**PROJECT NOTE NO. 50**

**SUBJECT: Marine Corps Base (MCB) Camp Pendleton Federal  
Facilities Agreement (FFA) Meeting (No. 101)**  
**DATE HELD: 19 August 2010**

# **MCB CAMP PENDLETON SUMMARY OF THE FFA TEAM COMMENTS ON THE 22/23 AREA GROUNDWATER RI/FS**

## **22/23 AREA GROUNDWATER RI/FS**

## Well 6W-01A:

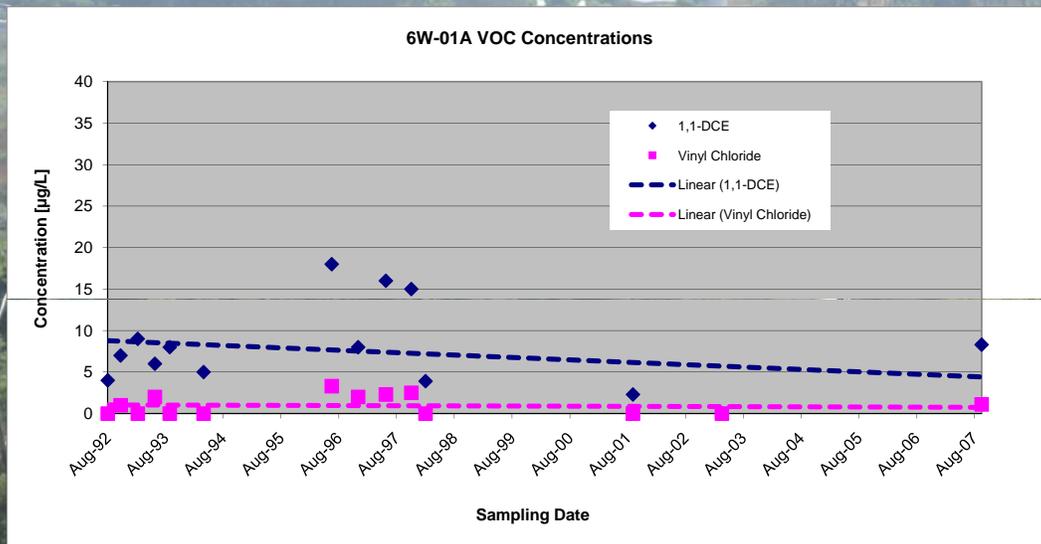
- ❖ The document states that there is a decreasing trend in contamination, but there are exceptions (6W-01A, 6MW-01, 6W-29, and 4W-04A); explain them.

- ❖ VOC concentrations have been slowly declining at the majority of the 50-plus monitoring wells within the 22/23 Area. However, the four wells cited in the comments are exceptions. At three of the four wells specified in this comment (6W-01A, 6MW-01, and 6W-29), the trend appears to be neither up nor down, but relatively stable over the entire monitoring program duration since the early 90s. There have been short term increases between some monitoring events. The major exception to the general trend in the monitoring wells is found at 4W-04A. This exception is pointed out and discussed in some detail within the document and the concentration trends at this location are the basis for labeling the area around this well as a hotspot. This hotspot is part of the potential remedial action in FS Alternative 4 (Source Area Treatment).
